**ZONING BOARD OF APPEALS
Regular Meeting Agenda
Wednesday February 05, 2025
6:30 P.M.**

Zoning Board of Appeals Staff Report

Applicant: Bank of America

Action Requested: Request for variance to the lighting requirements outlined in Article 13 – Section 1303.3 (A & B)

E-102

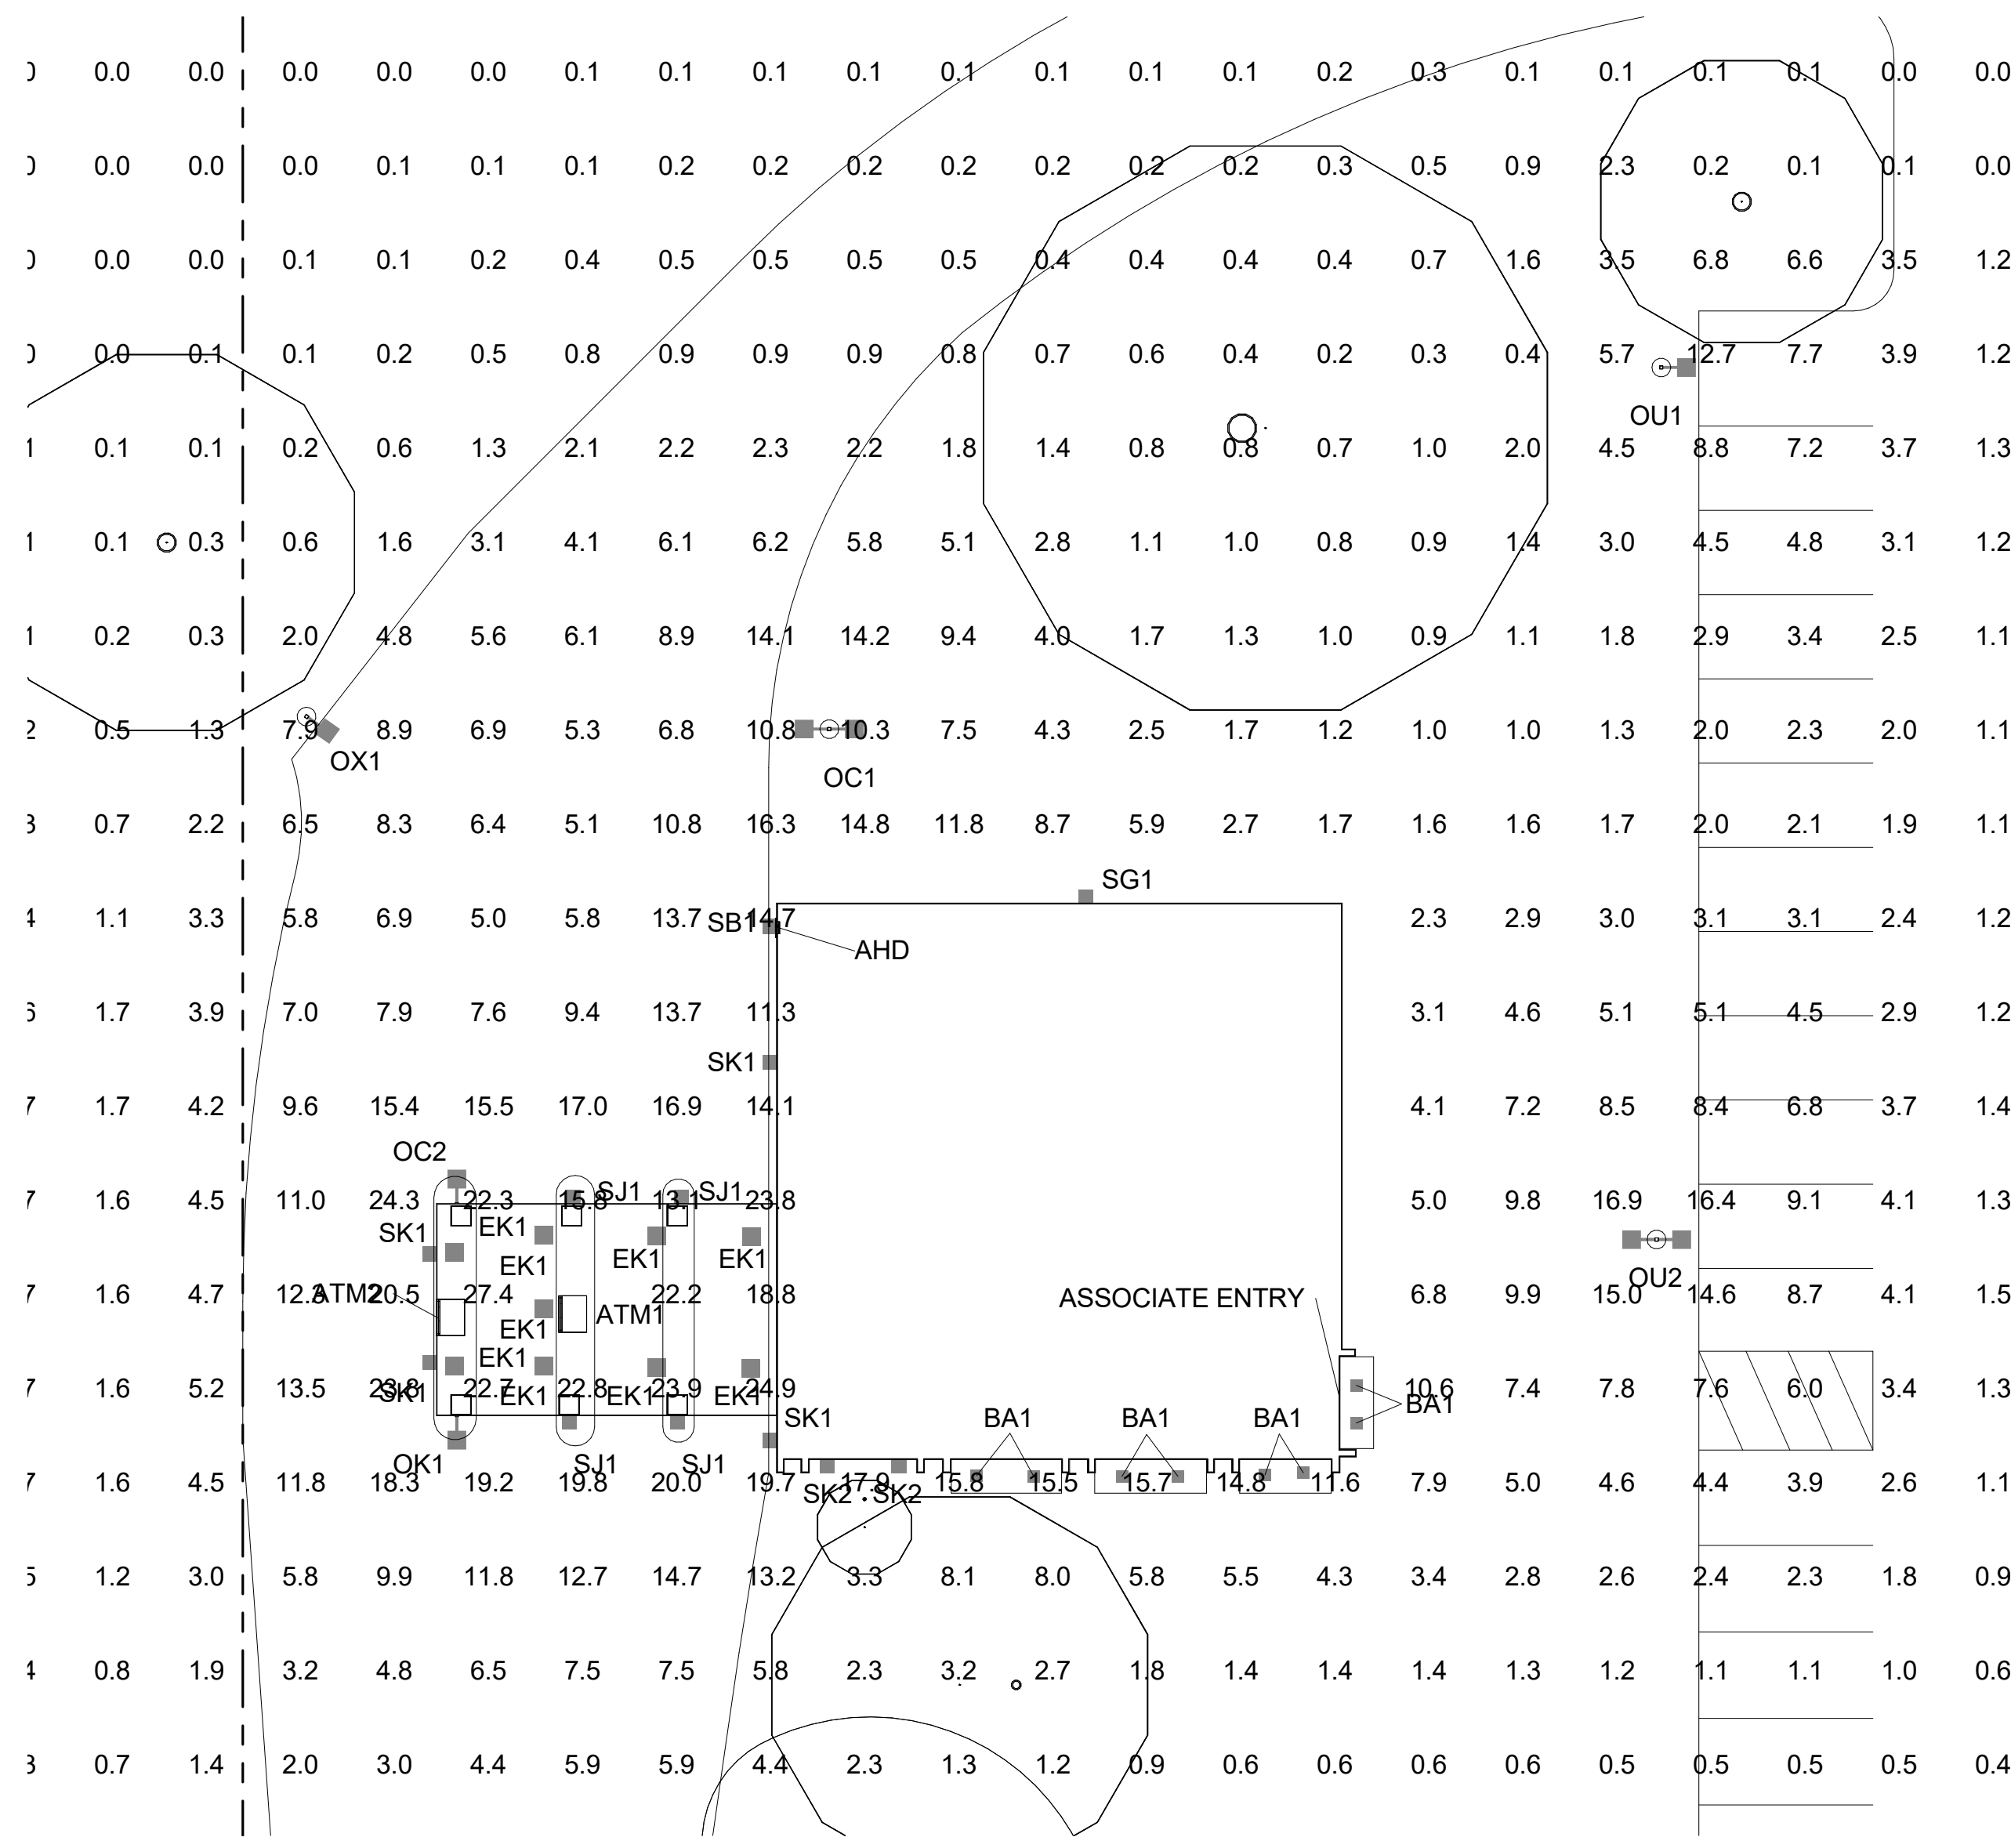
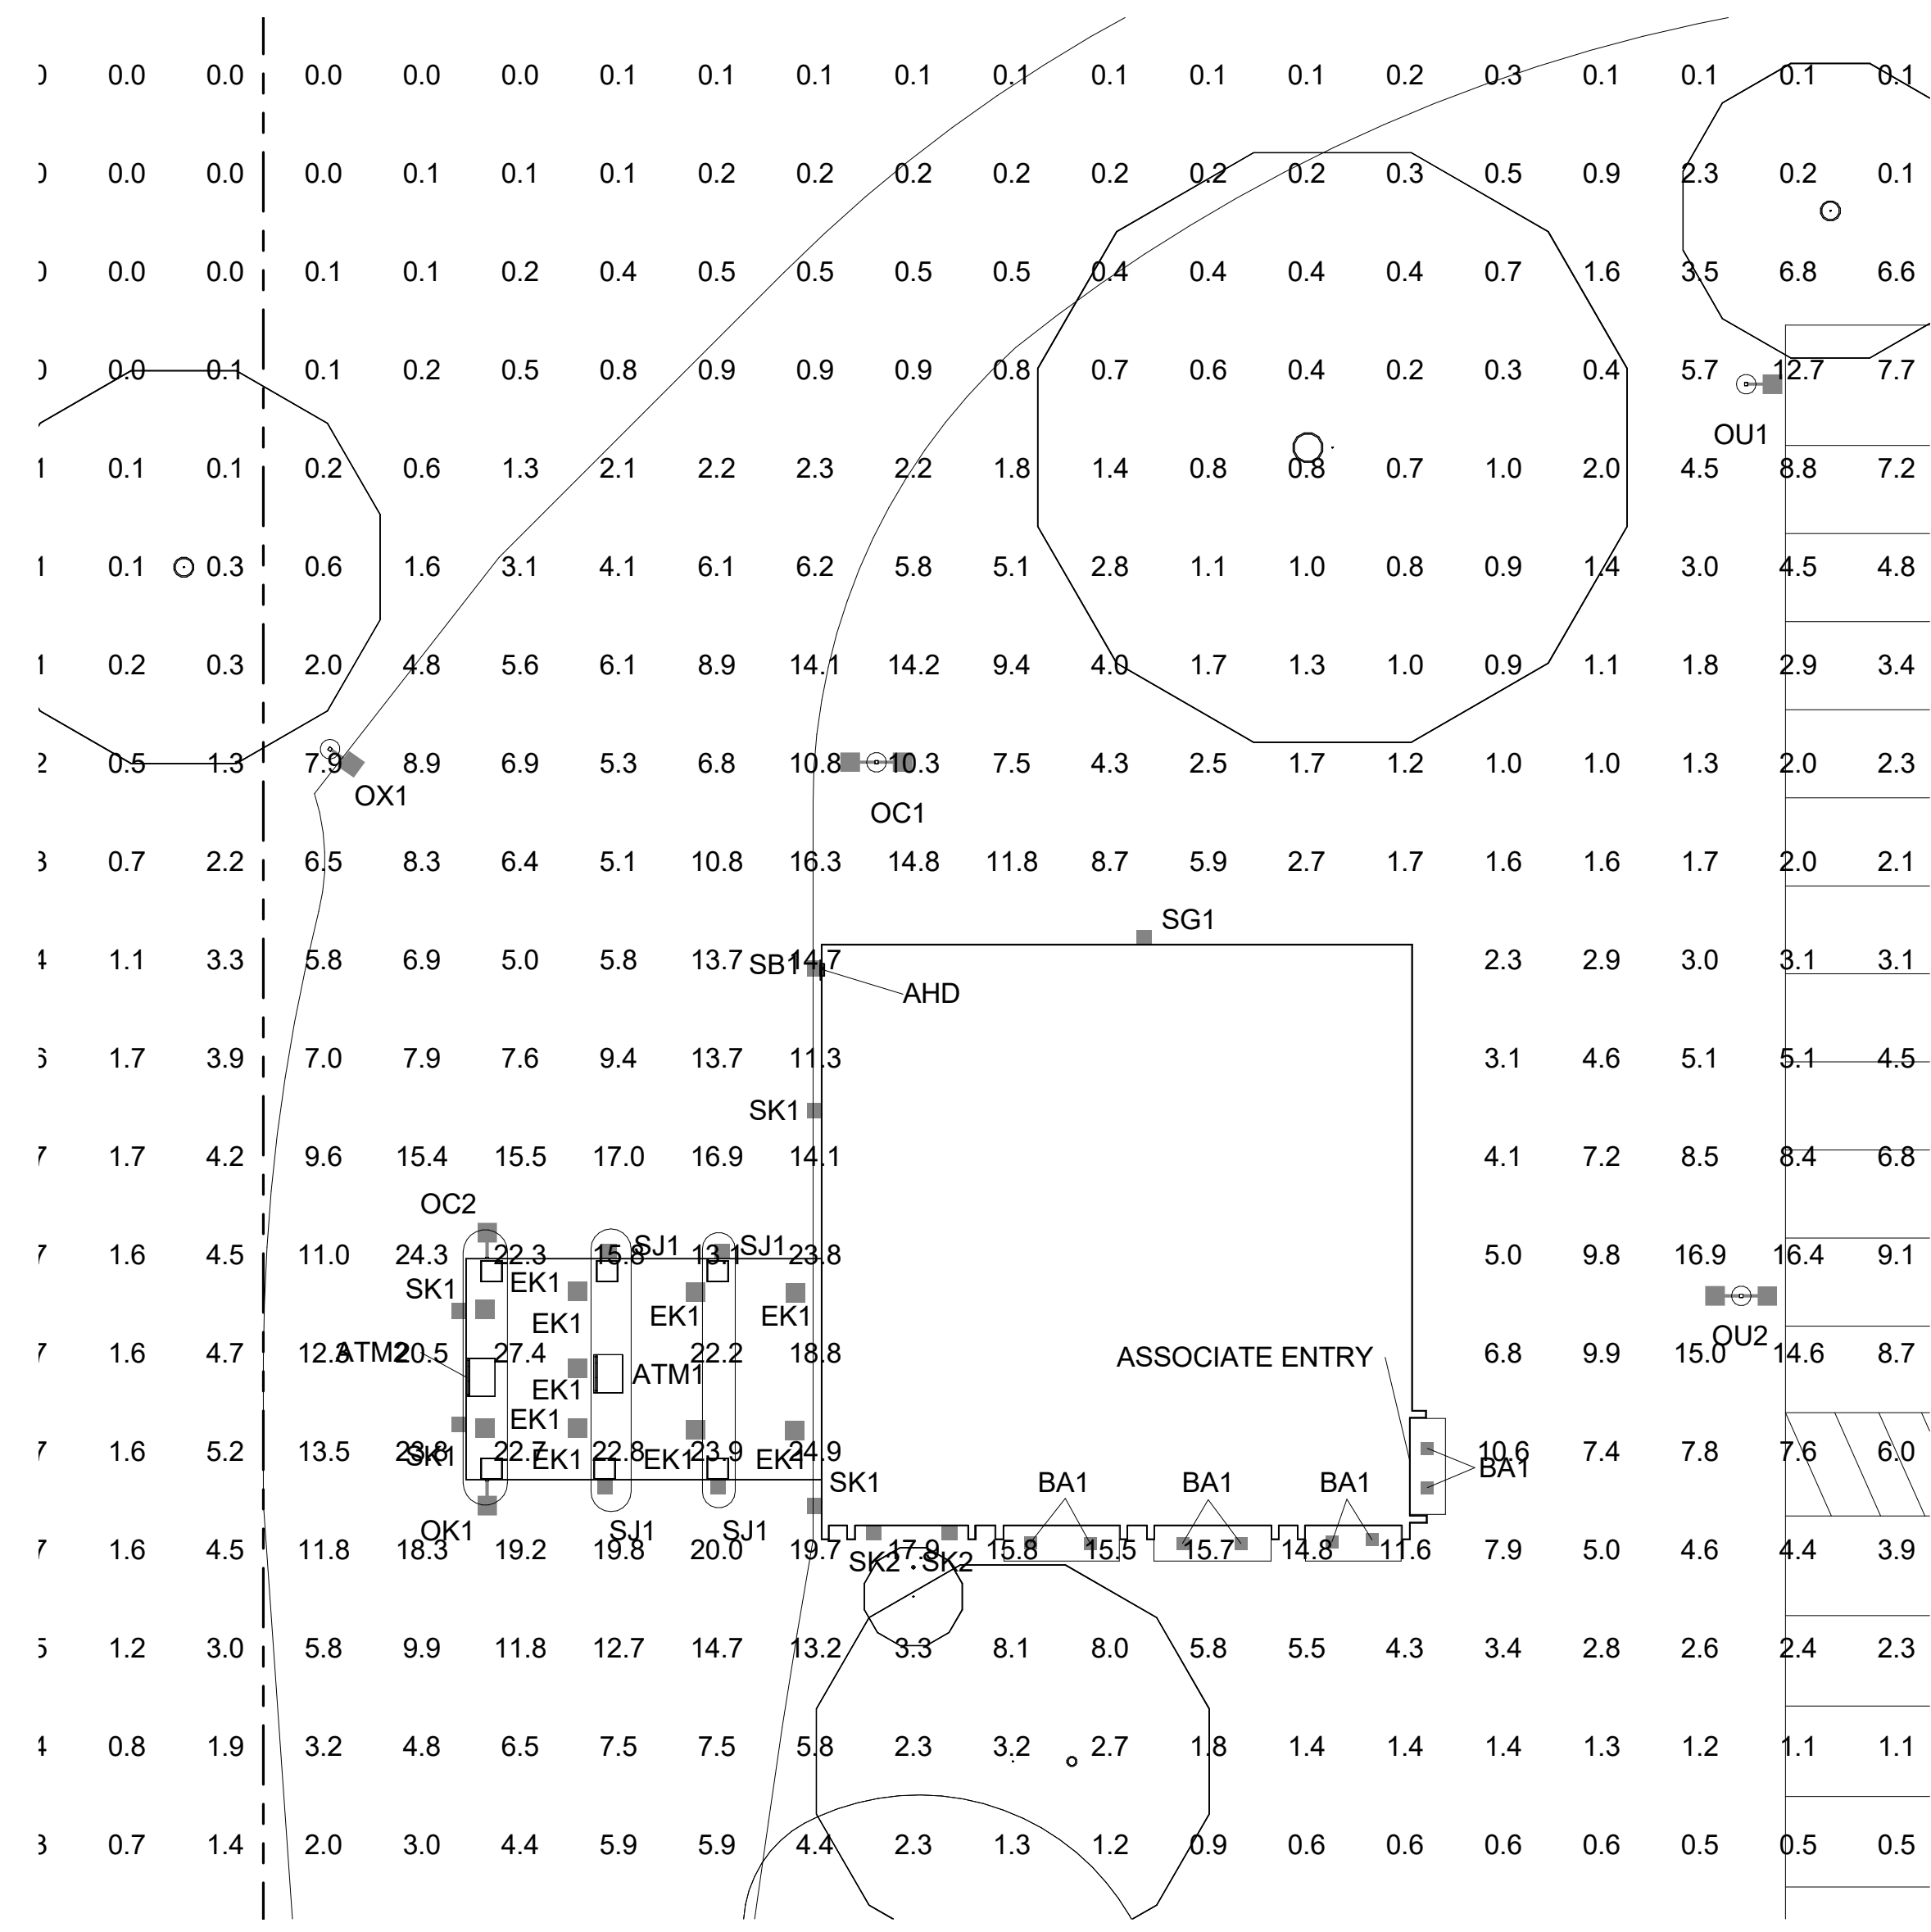
Lighting Regulation	Permitted Level	Submitted Plans	Variance Required
Maximum illumination at ground level along the western property line (adjacent to residential property)	0.5 footcandles	0.0 to 13.5 footcandles	Up to 13 footcandles above the permitted level
Maximum illumination at ground level in any given area	20.0 footcandles	0.0 to 27.4 footcandles	Up to 7.4 footcandles above the permitted level

The proposed lighting levels along the western property line, ranging from 0.0 to 13.5 footcandles, exceed the allowable limit of 0.5 footcandles adjacent to residential property. Additionally, the ground-level illumination of up to 27.4 footcandles exceeds the maximum permitted level of 20.0 footcandles. These increases could create light spillover and glare, potentially impacting the adjacent residential property and altering the character of the area. Approving the variance may undermine the intent of the ordinance to limit light pollution and protect residential uses.

The applicant has not provided a valid explanation or justification as to why compliance with the lighting regulations is not feasible. Based on the submitted information, the need for the variance appears to be self-created, as the site design and proposed lighting levels could potentially be modified to adhere to the ordinance.

The applicant has not demonstrated that the requested variance represents the minimum necessary or that alternative solutions—such as reducing light levels or modifying the lighting plan—are unfeasible. Without this information, it is not evident that the variance request is the least intrusive option to achieve the desired functionality.

I move to postpone the variance requests at 2250 W. Michigan Avenue, Ypsilanti, MI 48197, Parcel K-11-18-100-024 to the lighting requirements of Article 13, Section 1303.3(A & B) of the Township Zoning Ordinance, as shown on the plans submitted with the Zoning Board of Appeals Packet dated February 05, 2025. This postponement is to provide the applicant with an opportunity to address the comments made at this evening's meeting and return with a revised proposal that reflects those comments.
